DRAINAGE SUMMARY

PROJECT: MAUNALOA HIGHWAY, REPLACEMENT OF CULVERTS BETWEEN
MAUNALOA VILLAGE AND KAUNAKAKAI - PHASE II
PROJECT NO. RS-0460(3)

STATE OF HAWAII
DEPARTMENT OF TRANSPORTATION
HIGHWAYS DIVISION

Replacement of Culverts bet. Maunaloa
Village and Kaunakakai - Phase II

DETAILS OF 60" CULVERT AT STA. 41+42

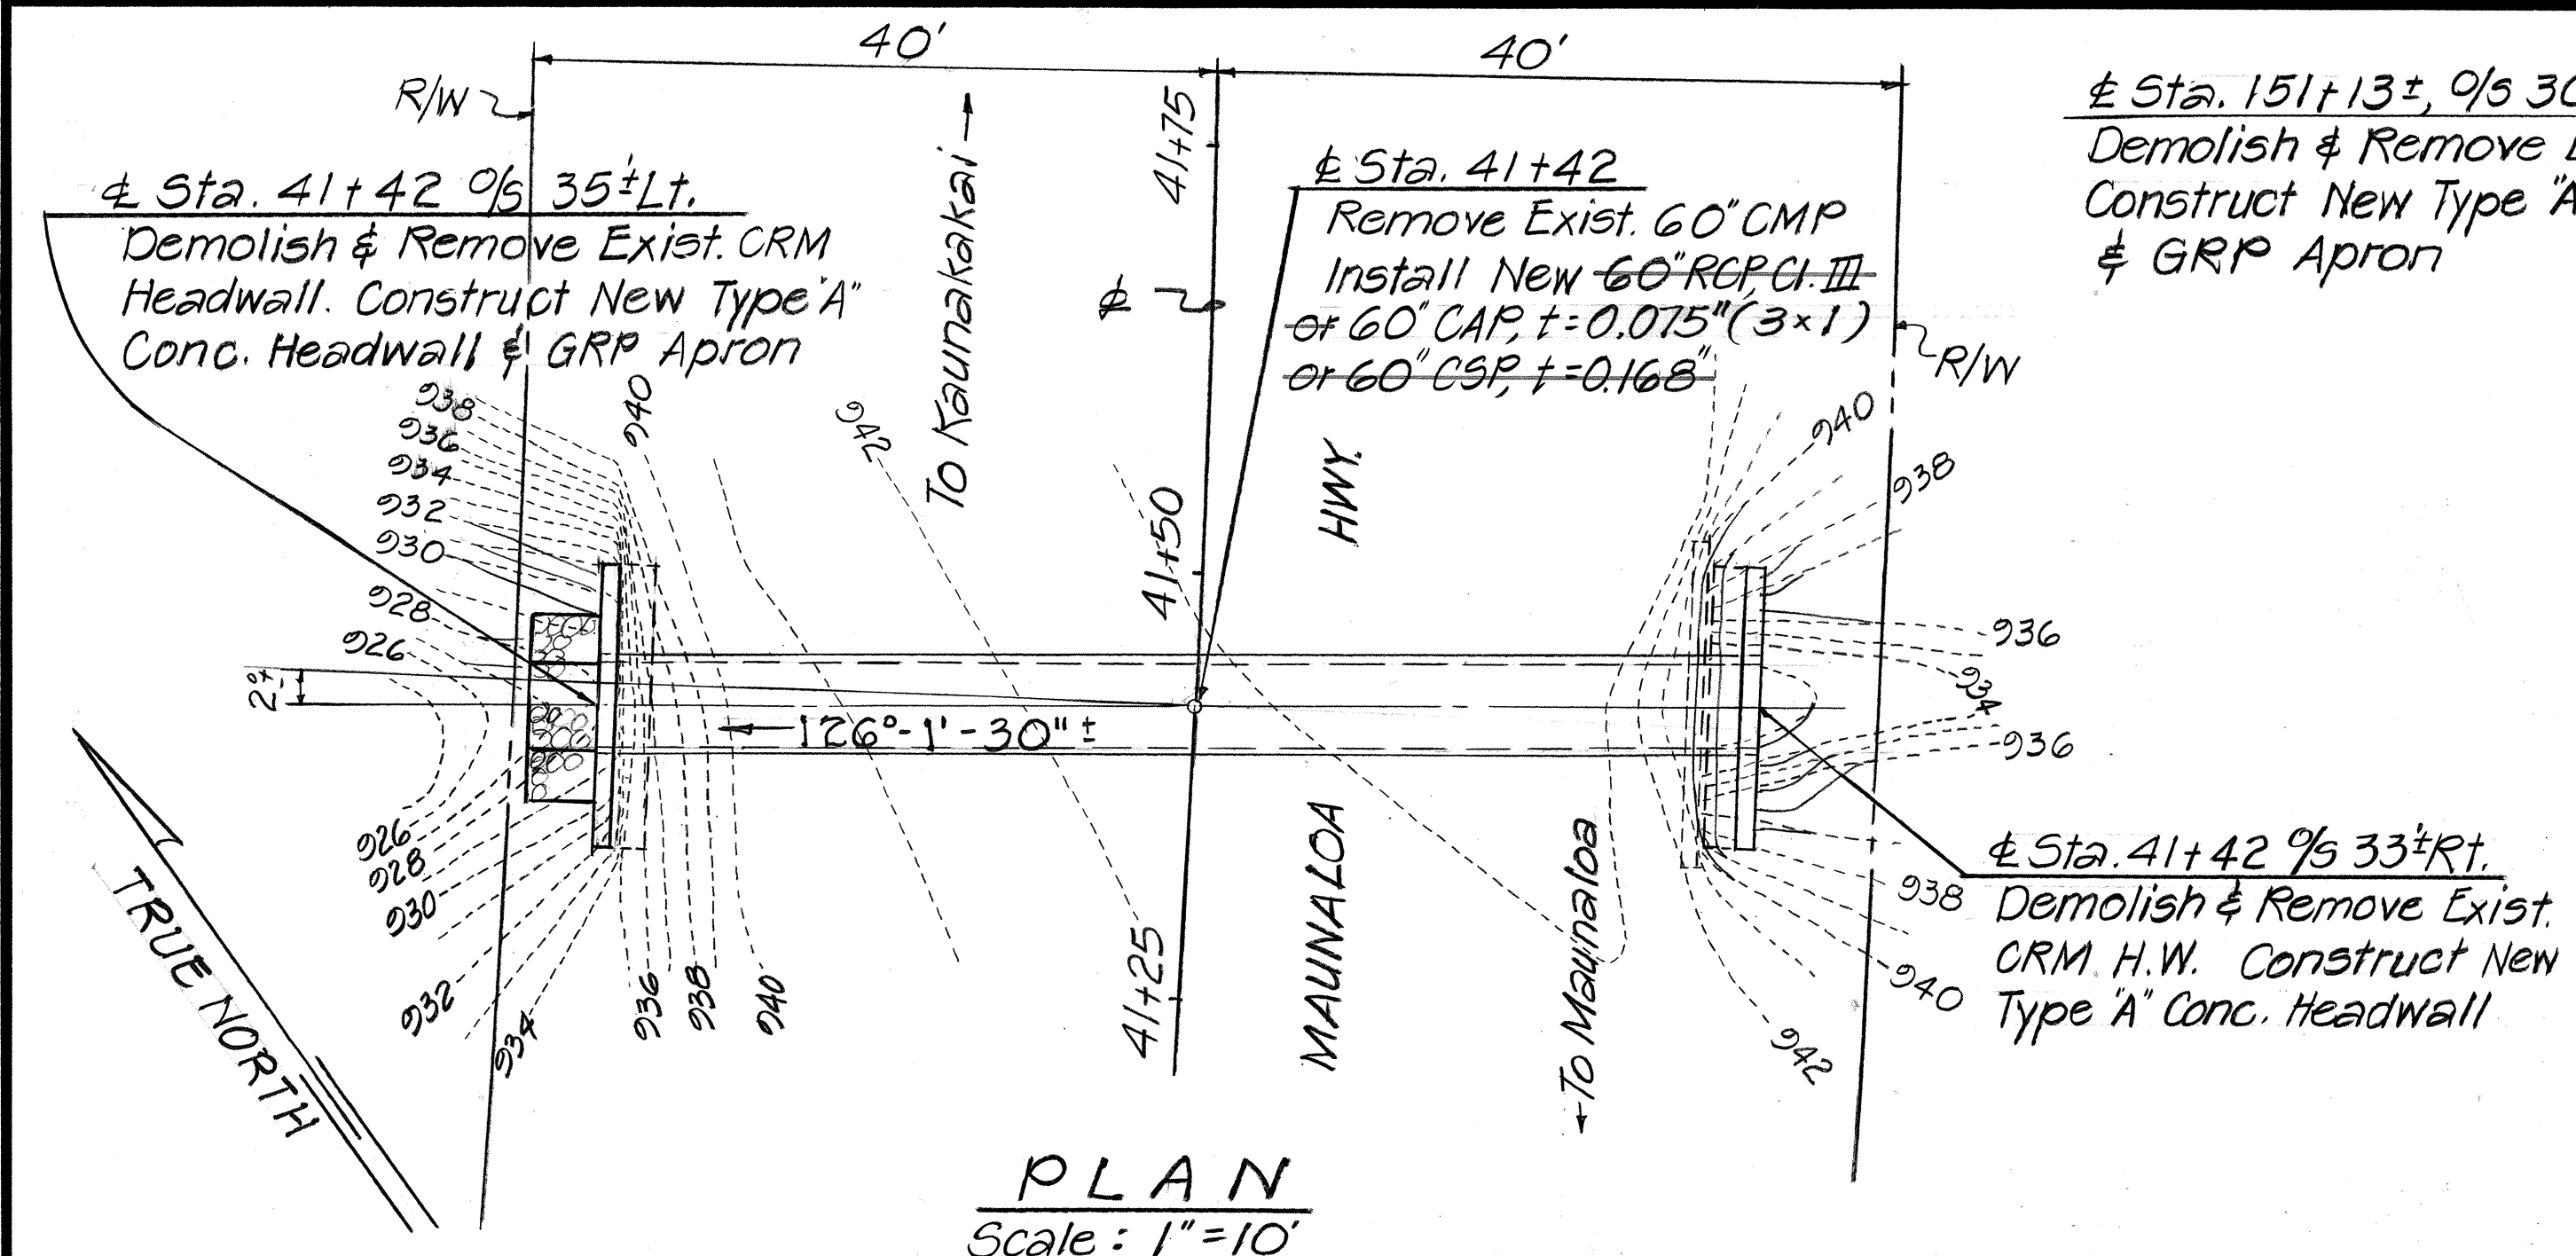
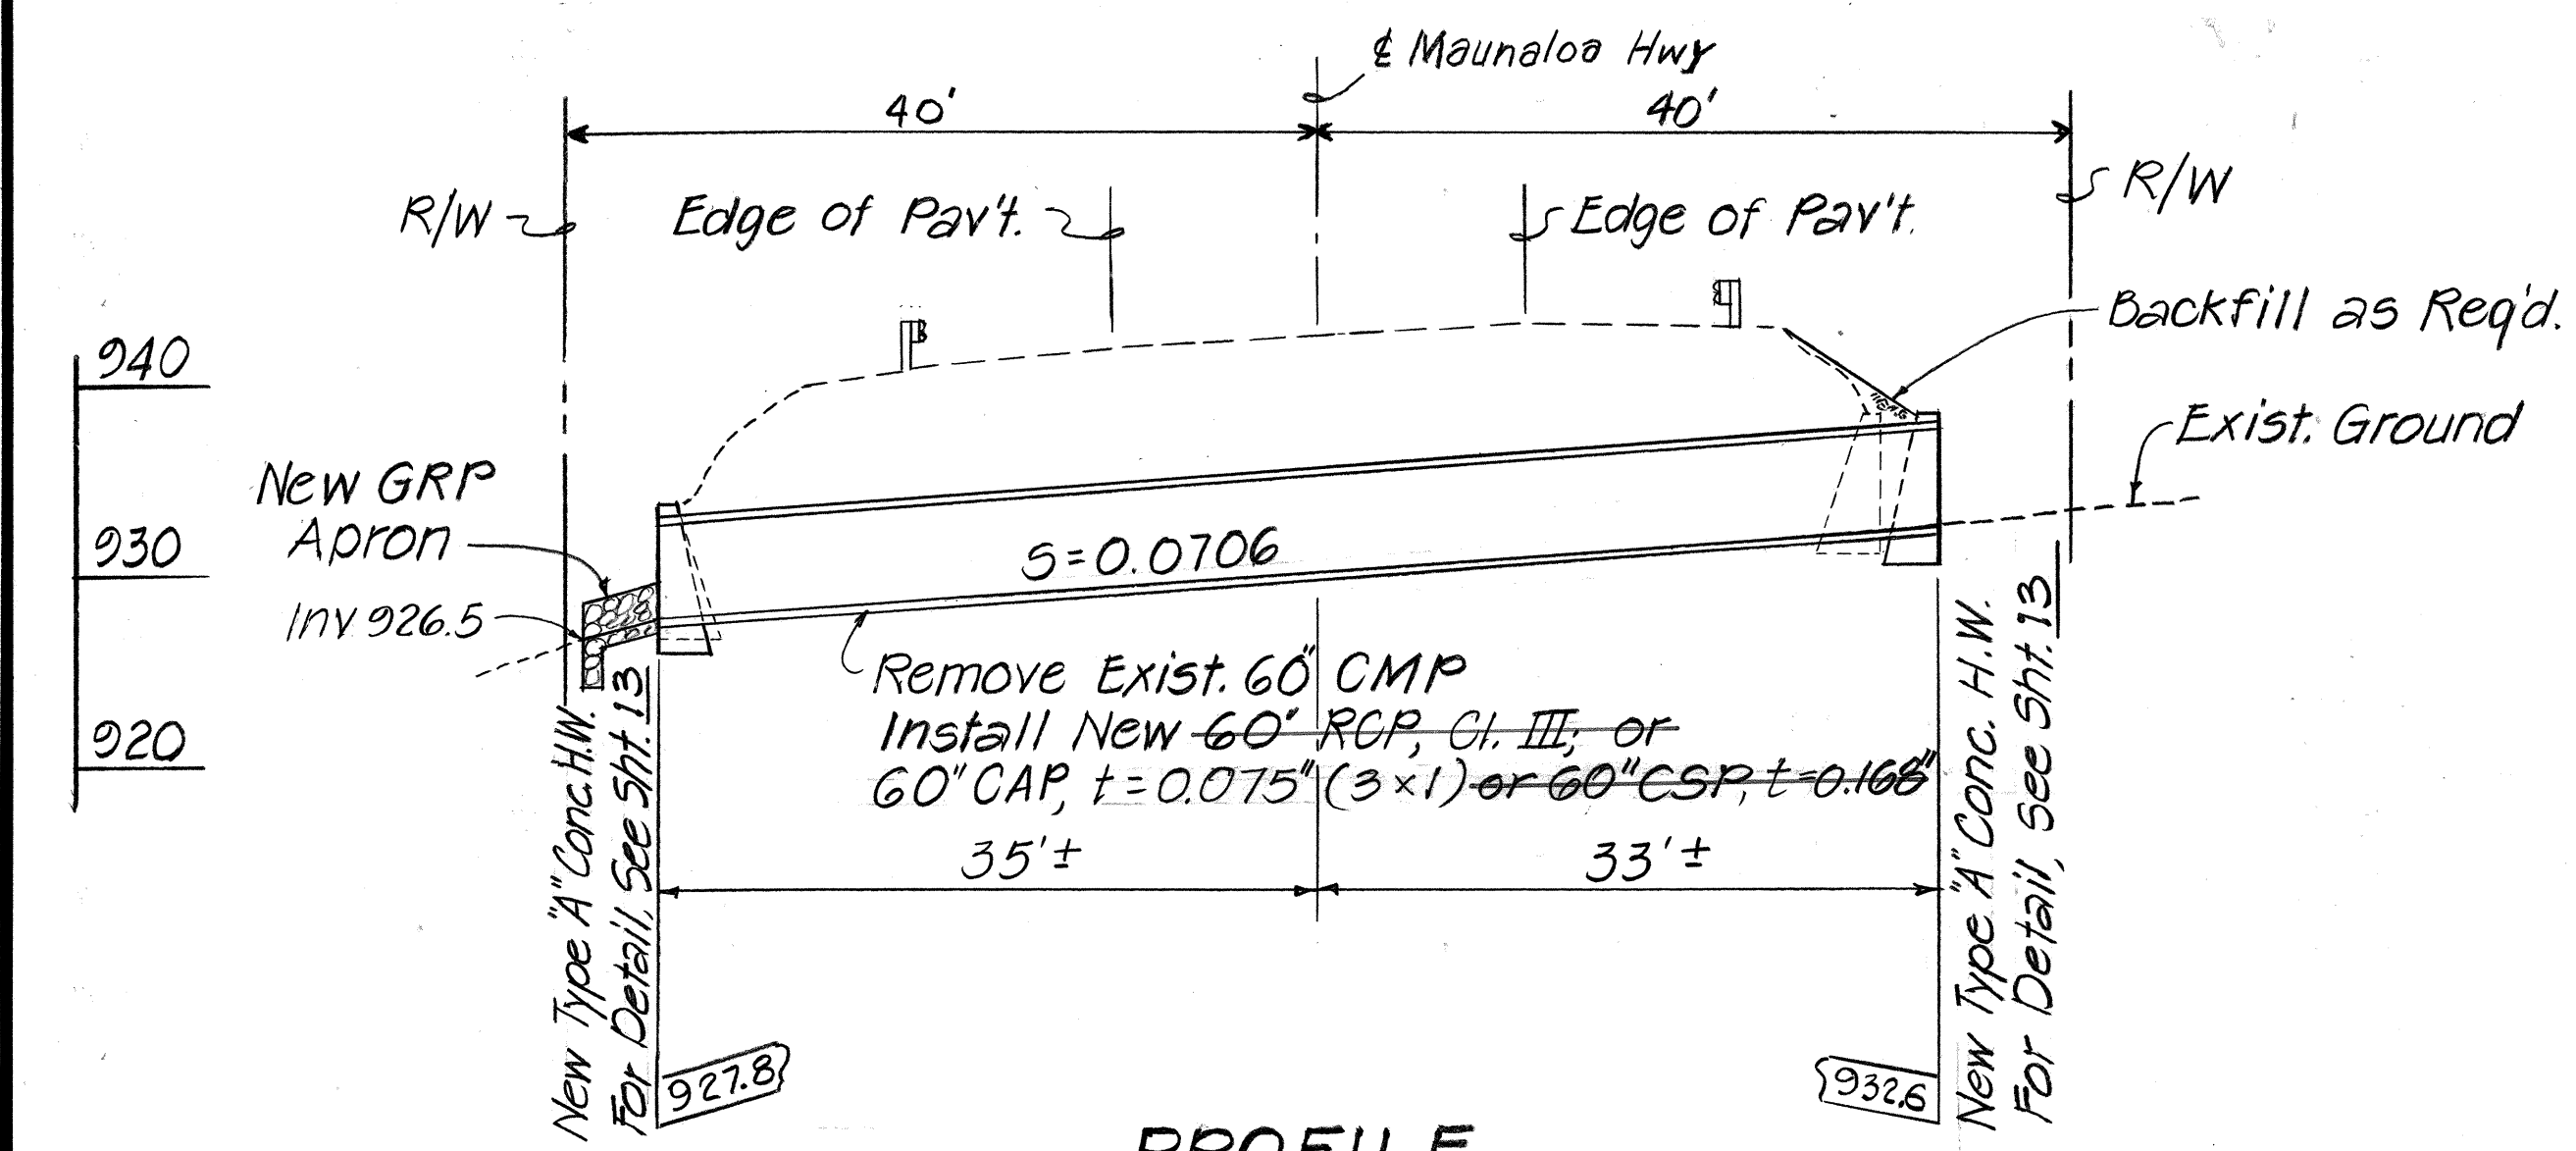
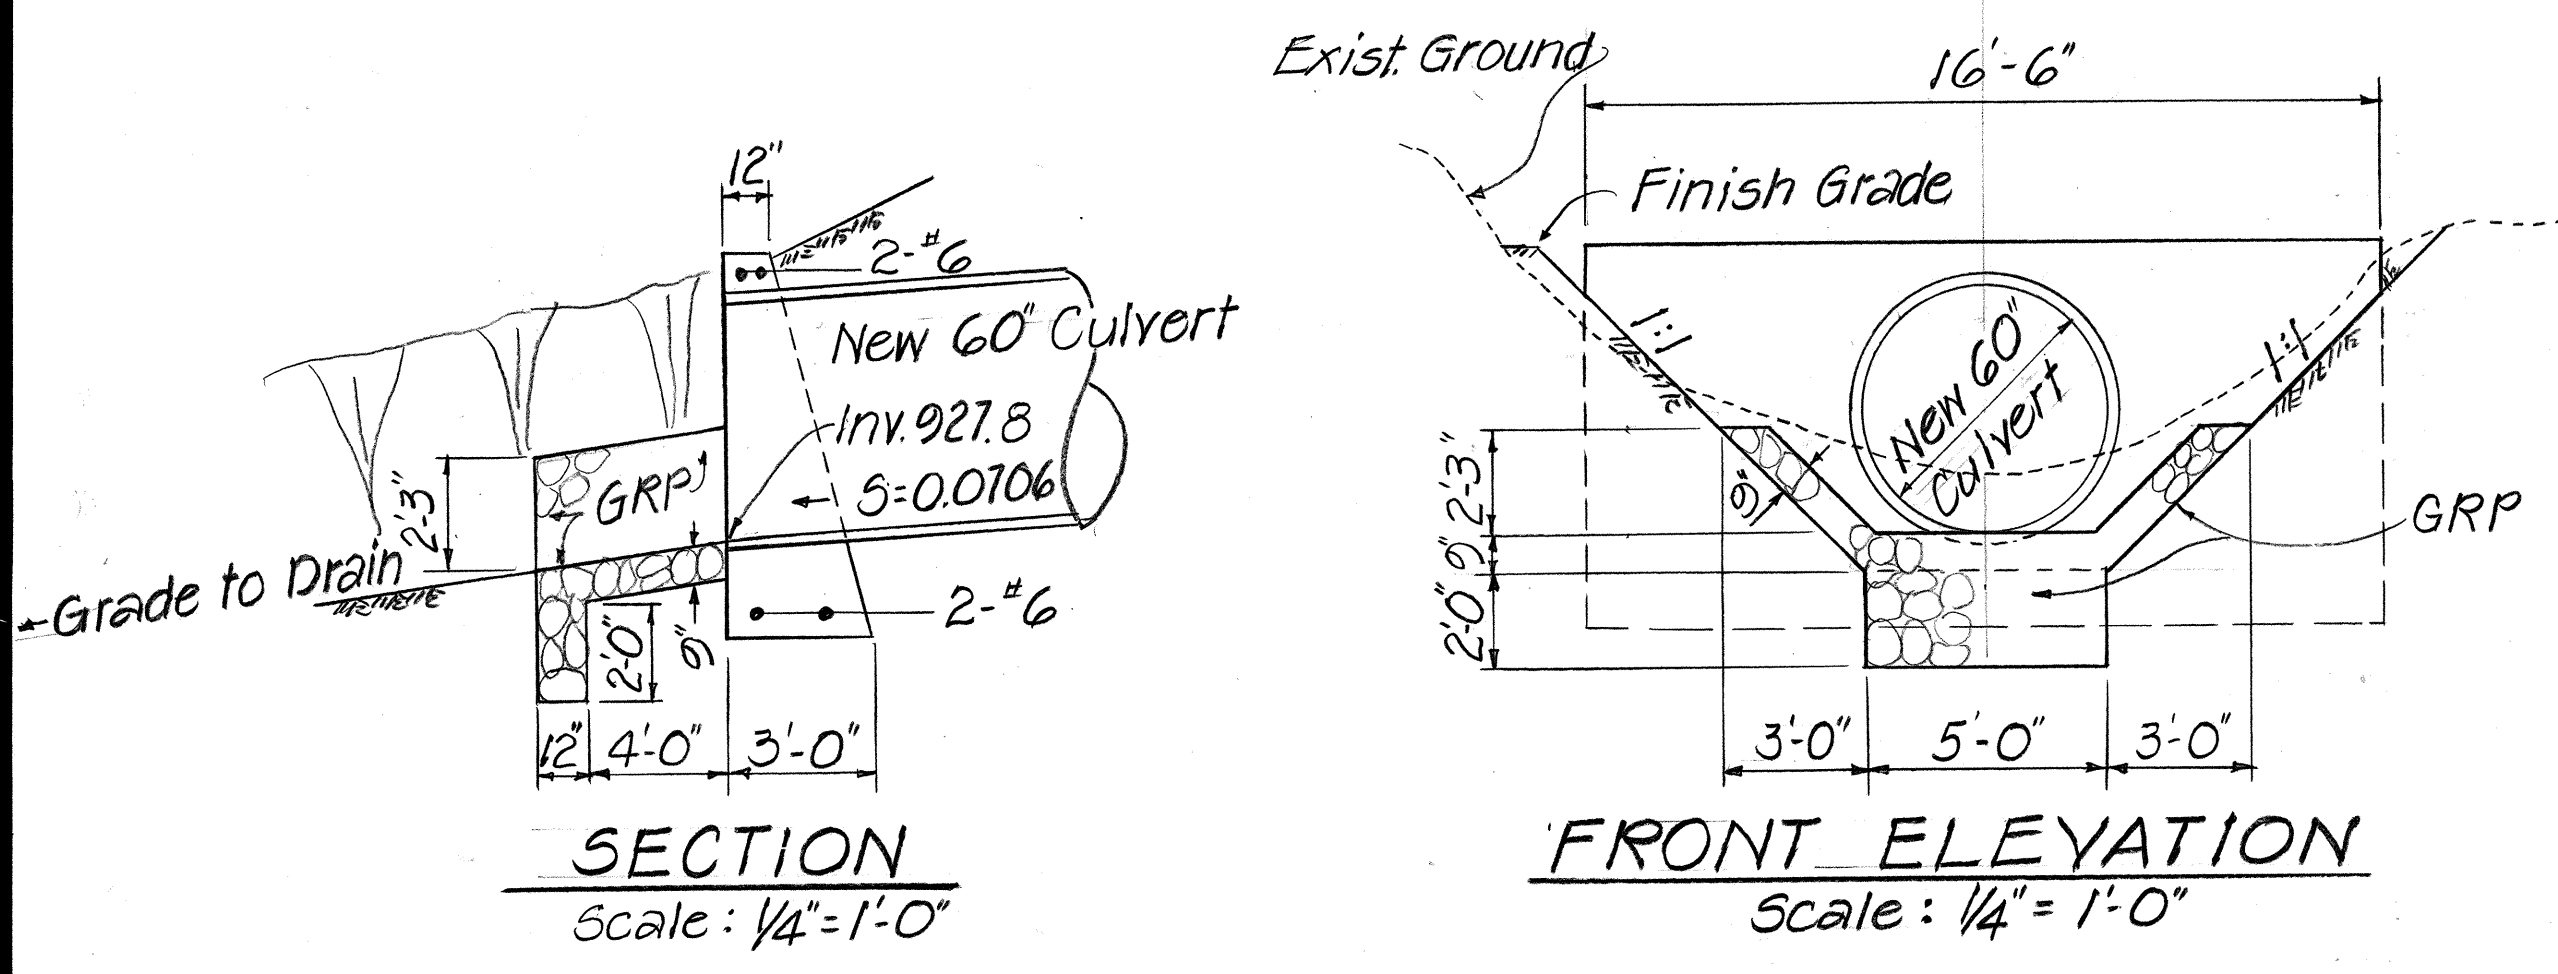
DATE	REVISION
10/23/84	Per Addendum No. 1 Changed 60" CAP t=0.135" to 60" CAP t=0.075" (3x1) and 60" CAP t=0.164" to 60" CAP t=0.075" (3x1)
